STAFF RECOMMENDATION
1419 Holly Street
April 15, 2015

Application: New construction-detached accessory dwelling unit (DADU); Setback determination

Description of Project: New construction of an outbuilding for use as a garage and detached accessory dwelling unit (DADU). The project includes a driveway that exceeds the twelve foot (12') maximum allowed by Chapter 17.16.030.F. of the Metro Code. The applicant requests a setback determination for the side setback.

A1 ARCHITECTURAL SITE PLAN
SCALE: 1/16"=1'-0"

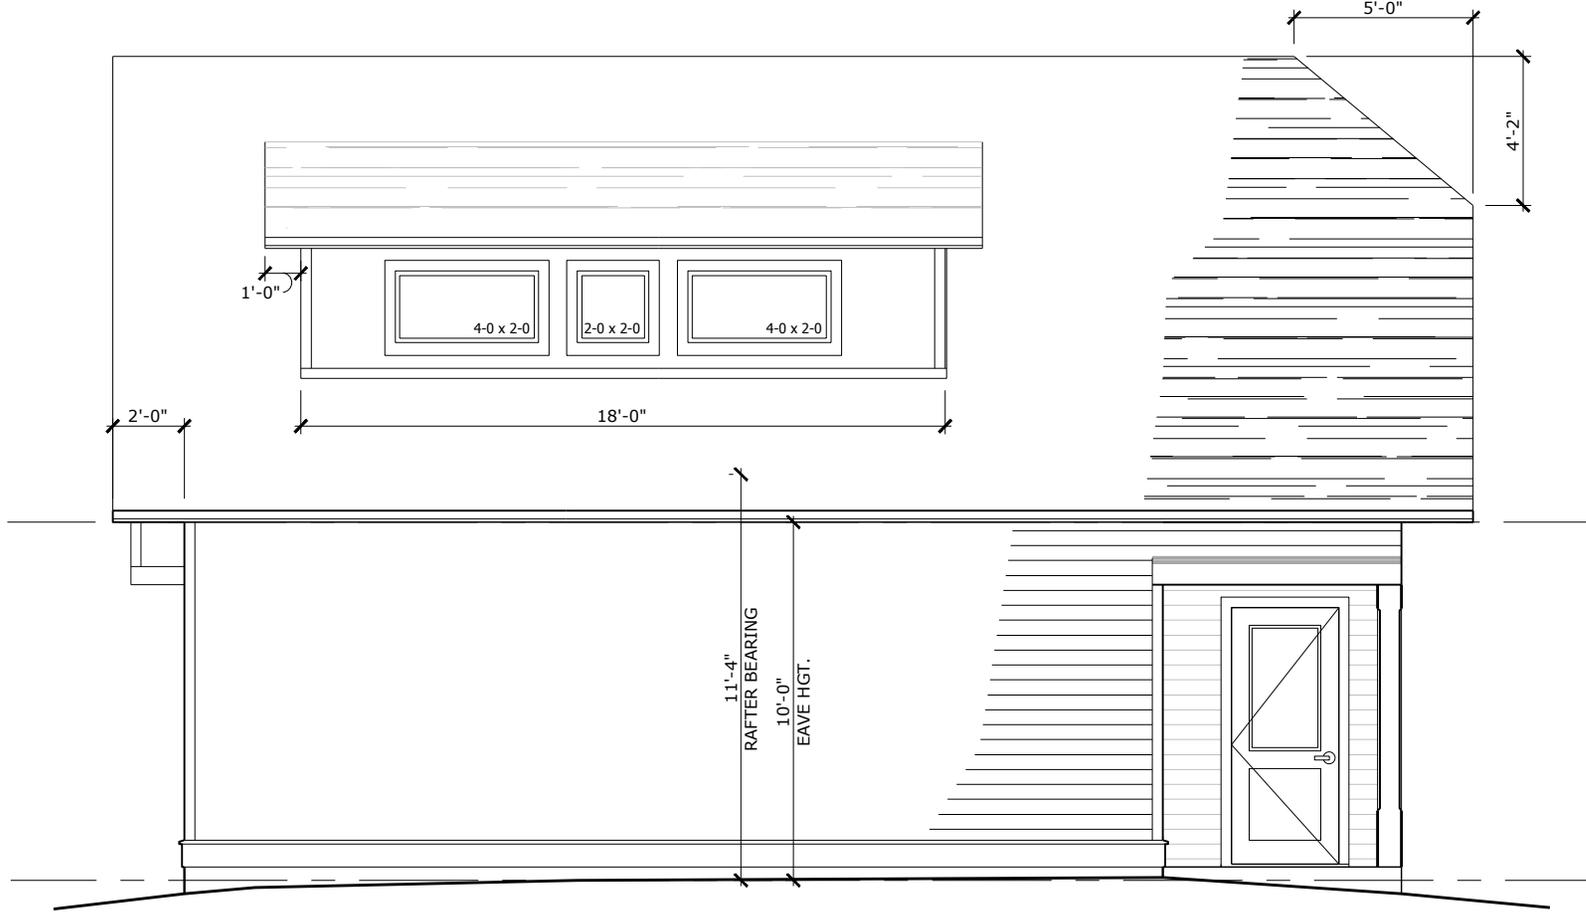
There is an existing alley; however, there is also an existing curbcut. With a two-bay garage, the curbcut becomes double-width, essentially adding a second curbcut which the ordinance does not allow. There are several options. The vehicular entrances could be reoriented to face the alley, deleting the need for any curbcut. The building could be

redesigned so that one vehicular entrance faces the alley and only one faces the street; however this would likely result in a footprint too large to meet the code requirements. The third option is that the building could be pushed back onto the lot far enough that the curbcut could be no more than the allowed twelve feet (12') at the street and can bloom out inside the lot to accommodate the two doors. The MHZC does not have the authority to alter the requirement of the curbcut not exceeding twelve feet (12') in width.

In addition, with the garage doors facing the alley, as currently proposed, Metro Code 17.20.060.D requires a minimum setback of twenty feet (20') from the street. Staff's recommendation to retain that requirement of a twenty foot (20') setback also meets section II.B.9 of the design guidelines that requires driveways to be similar to the context. The outbuilding across North Fifteenth Street appears to have a setback that is similar to twenty-feet (20') requirement. (See vicinity map on page 2.)

1. The outbuilding is oriented with the garage doors facing the alley;
2. The outbuilding is setback at least 20' from North Fifteenth Street; and,
3. Staff approve the final details, dimensions and materials of windows, doors and garage doors prior to purchase and installation.
